# LAND AT NORTH WEST BICESTER

## TRANSPORT ASSESSMENT VOL 2 (ii) – APPENDIX E - J

Stage 1 Road Safety Audit & Designer's Response

## STAGE 1 RSA DESIGNER'S RESPONSE

DRAWING TITLE  
**POSSIBLE B4100/CHARLOTTE AVENUE TRAFFIC SIGNALS**

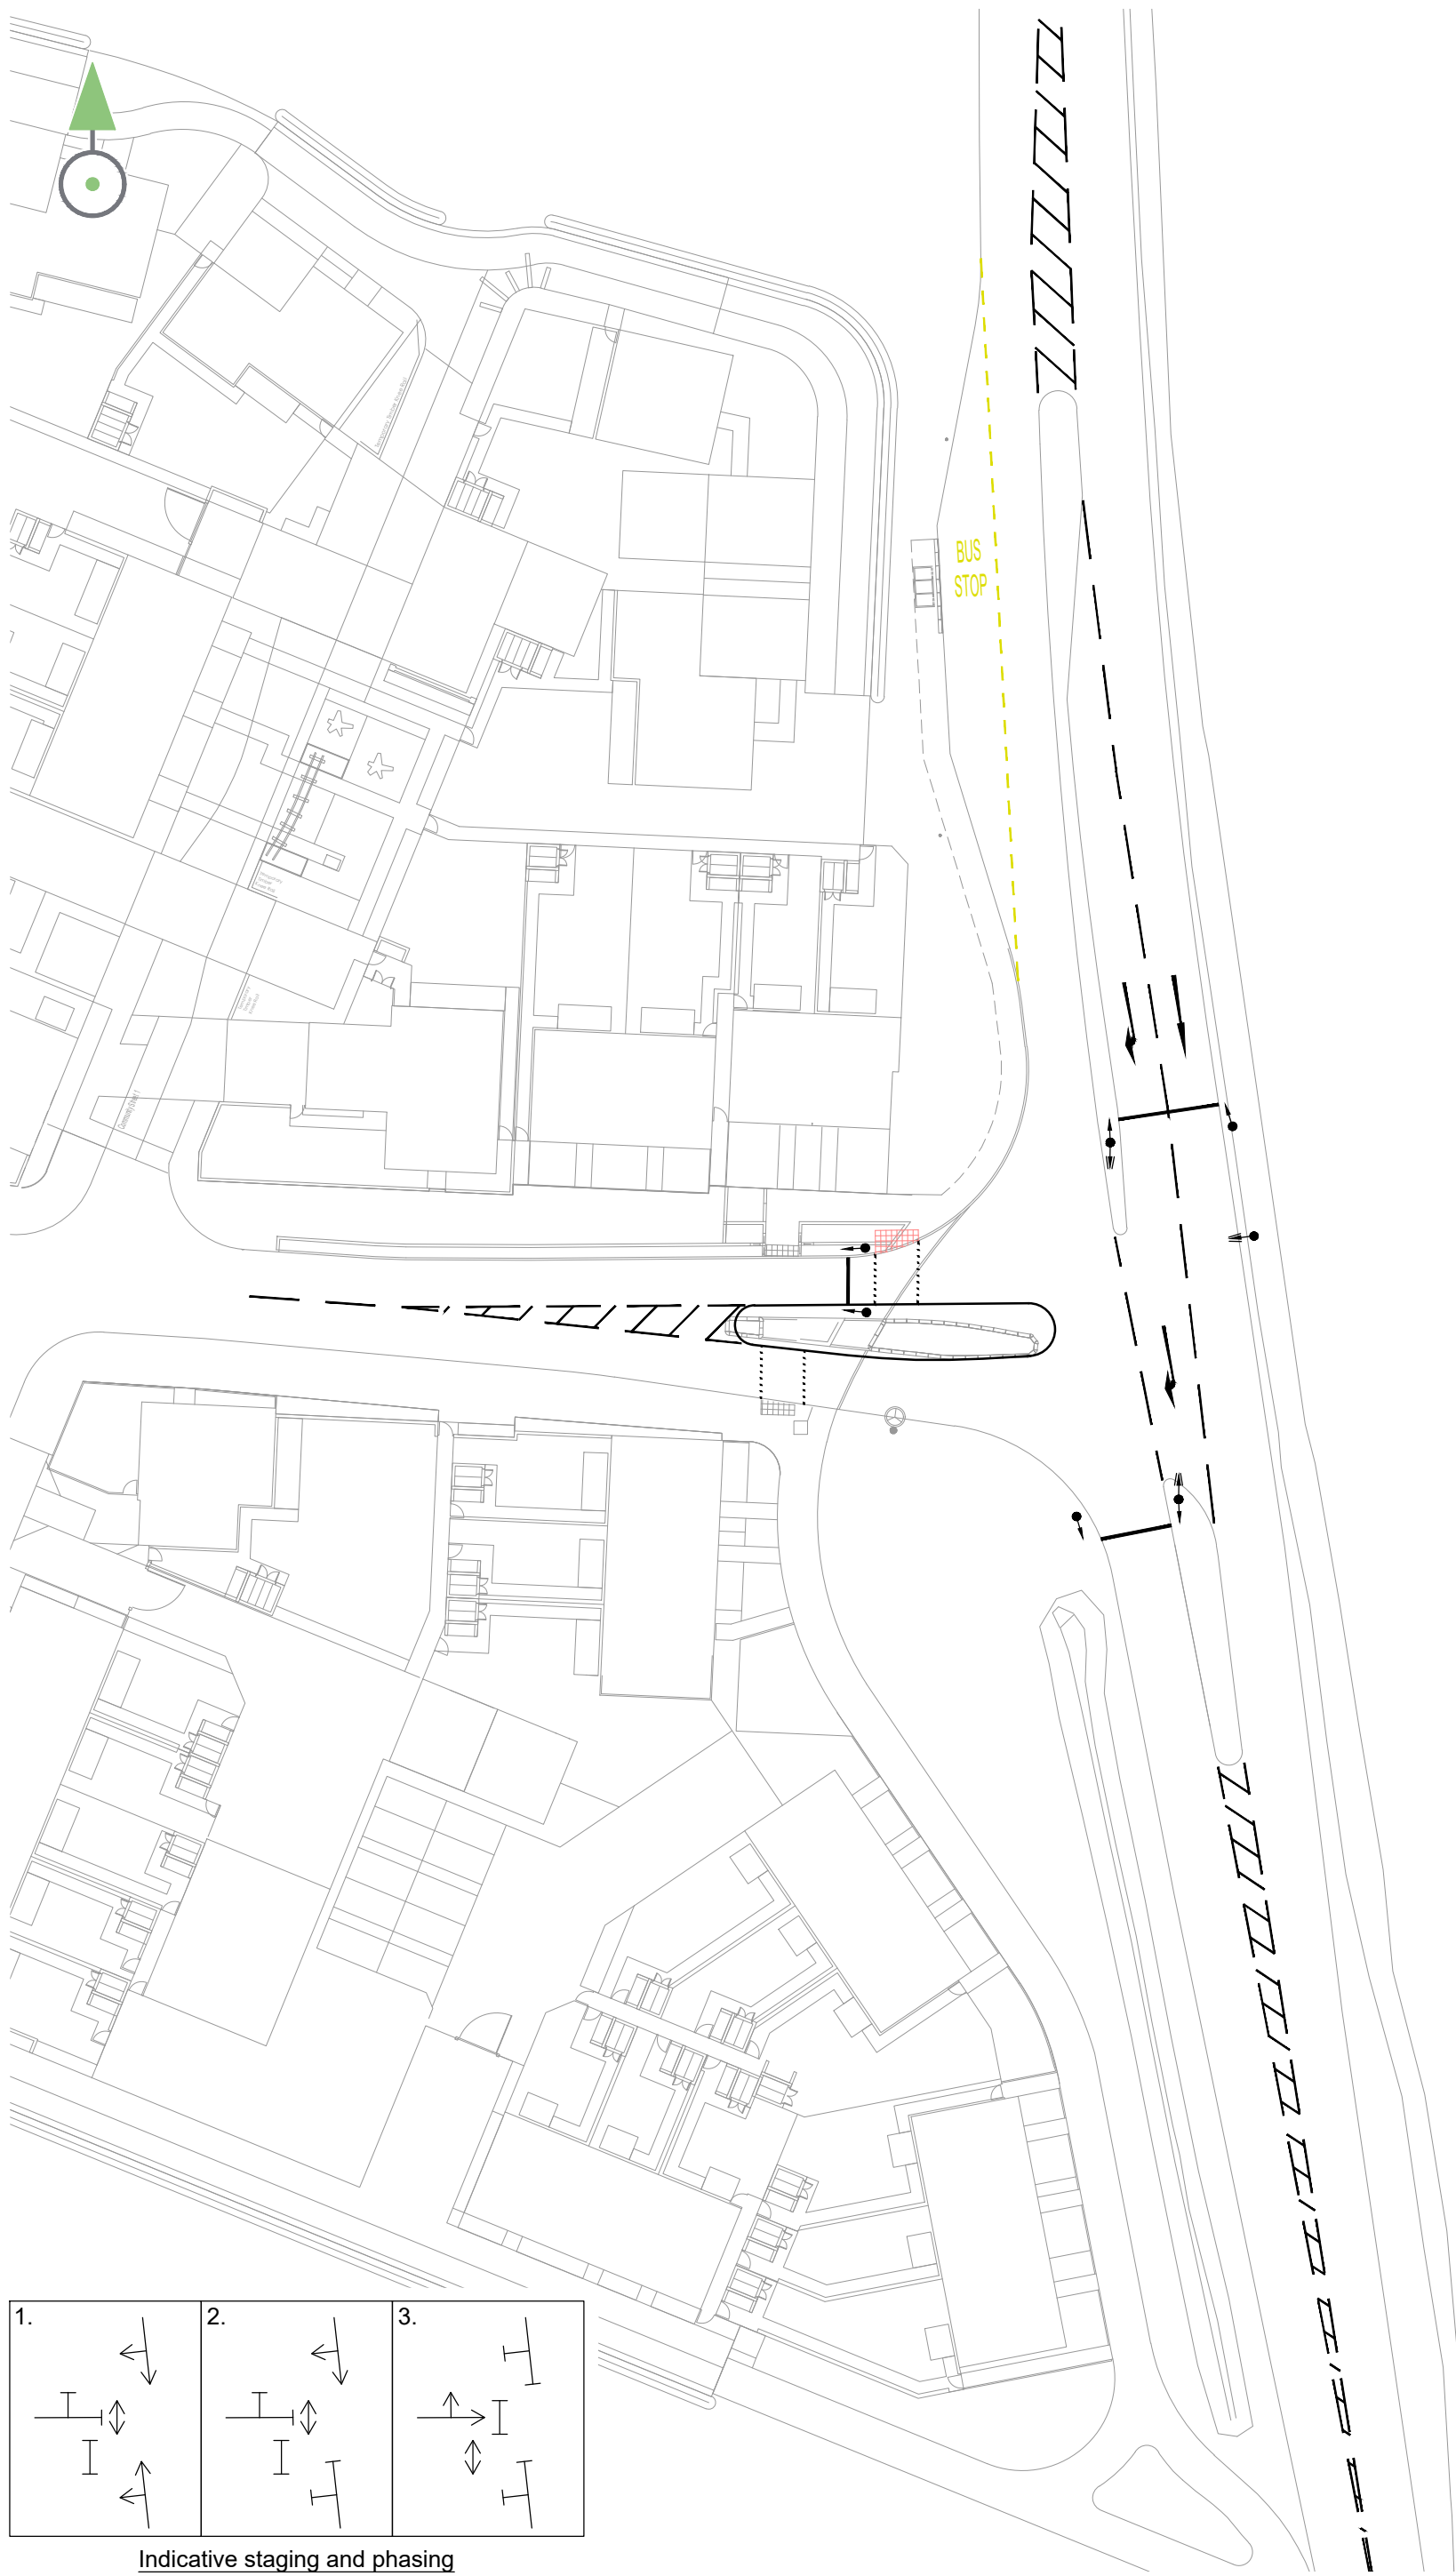
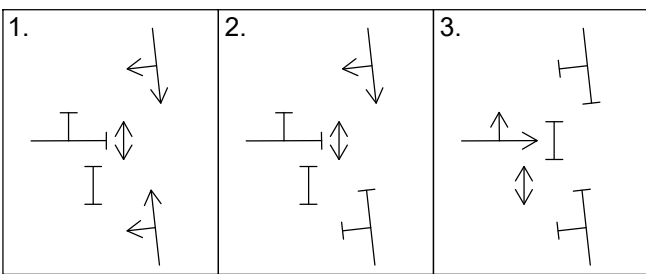
<b>3.4 – Charlotte Avenue Traffic Signal Controlled Junction (Drawing 4600-1100-T-016 Rev A)</b>				
3.4.1	<p><b>Location:</b> At the junction</p> <p><b>Summary:</b> Pedestrian to vehicle collisions involving main road right turning vehicles</p> <p>The staging layout on the drawing indicates that right turners turn within gaps in the opposing traffic or within the inter-green period.</p> <p>The stacking space for waiting right turners may lead to up to four / five vehicles passing the signal stop line and attempting to clear the junction in the intergreen period. The intergreen period at the end of stage 1 may not be sufficient to clear the right turn queue leading to an increased risk of pedestrian to vehicle collisions at the crossing</p>	<p>It is recommended that the right turn manoeuvre is positively signalled, to minimise the possible pedestrian to vehicle conflict. Measures may include an early cut off with an indicative arrow and that an adequate inter-green period is provided to ensure queuing right turn vehicles can clear the crossing area before the pedestrian crossing signal is given a green person aspect.</p>	<p>The design of the traffic signal junction has been revisited to ensure that adequate time is afforded to the right turners to perform the manoeuvre. The results of this revised signal arrangement are set out within the supporting Transport Assessment.</p>

3.4.2	<p><b>Location:</b> At the junction</p> <p><b>Summary:</b> Collisions involving main road right turning vehicles</p> <p>The staging layout on the drawing indicates that right turners turn within gaps in the opposing traffic or within the inter-green.</p> <p>The junction layout on the drawing indicates a far sided secondary signal head for the southbound traffic stream. Drivers making the main road right turn manoeuvre may take their cue to commence a right turn based on this signal aspect. With the 40mph speed limit and observed high northbound speeds, northbound vehicles passing the stop line at the end of the stage may come into conflict with right turning vehicles</p>	<p>It is recommended that the right turn manoeuvre is positively signalled, to minimise the possible right turn across path conflict. Measures may include an early cut off with an indicative arrow or if the staging arrangement is to remain as a two stage, the far sided signal aspect should be relocated to be closely associated.</p>	<p>See comment above.</p>

3.4.3	<p><b>Location:</b> At the junction</p> <p><b>Summary:</b> Pedestrian to vehicle collisions leading to pedestrian injury</p> <p>The Linsig analysis shows no inter-green period between the termination of the traffic phase D to the start of pedestrian phase E and vice a versa. If insufficient time is provided between the termination of these phases, it may lead to a slow walking pedestrian being hit by a vehicle, leading to pedestrian injury</p>	It is recommended that appropriate inter-green periods are provided between the phases	See comment above.	
<b>4.0 – Other Observations</b>

The staging layout on the drawing indicates that right turners turn within gaps in the opposing traffic or within the inter-green period.

The stacking space for waiting right turners may lead to up to four / five vehicles passing the signal stop line and attempting to clear the junction in the intergreen period. The intergreen period at the end of stage 1 may not be sufficient to clear the right turn queue leading to an increased risk of pedestrian to vehicle collisions at the crossing.

It is recommended that the right turn manoeuvre is positively signalled, to minimise the possible pedestrian to vehicle conflict. Measures may include an early cut off with an indicative arrow and that an adequate inter-green period is provided to ensure queuing right turn vehicles can clear the crossing area before the pedestrian crossing signal is given a green person aspect.

The junction layout on the drawing indicates a far sided secondary signal head for the southbound traffic stream. Drivers making the main road right turn manoeuvre may take their cue to commence a right turn based on this signal aspect. With the 40mph speed limit and observed high northbound speeds, northbound vehicles passing the stop line at the end of the stage may come into conflict with right turning vehicles.

The Linsig analysis shows no inter-green period between the termination of the traffic phase D to the start of pedestrian phase E and vice a versa. If insufficient time is provided between the termination of these phases, it may lead to a slow walking pedestrian being hit by a vehicle, leading to pedestrian injury.

It is recommended that appropriate inter-green periods are provided between the phases.

It is unclear from the information provided (as indicated by the tactile paving layout), whether the crossing on Charlotte Avenue will be installed as controlled crossing with traffic signal push button units and indicators) or as an uncontrolled crossing, although the phasing diagram appears to show the pedestrian movements as signal phases.

It is recommended the type of crossing should be clarified and at the detail design stage the colour and layout of the tactile paving should comply with latest guidance for the chosen crossing type.

B	13.04.21	Staging diagram amended	MP
A	25.03.21	First issue	MP
REV	DATE	COMMENT	APP
REVISION DETAILS			
DRAWING NO.			
<b>4600-1100-T-016</b>			
DRAWN	APPROVED	DATE	
TC	MP	MAR 21	
SCALE			REV
1:500 @ A3			B
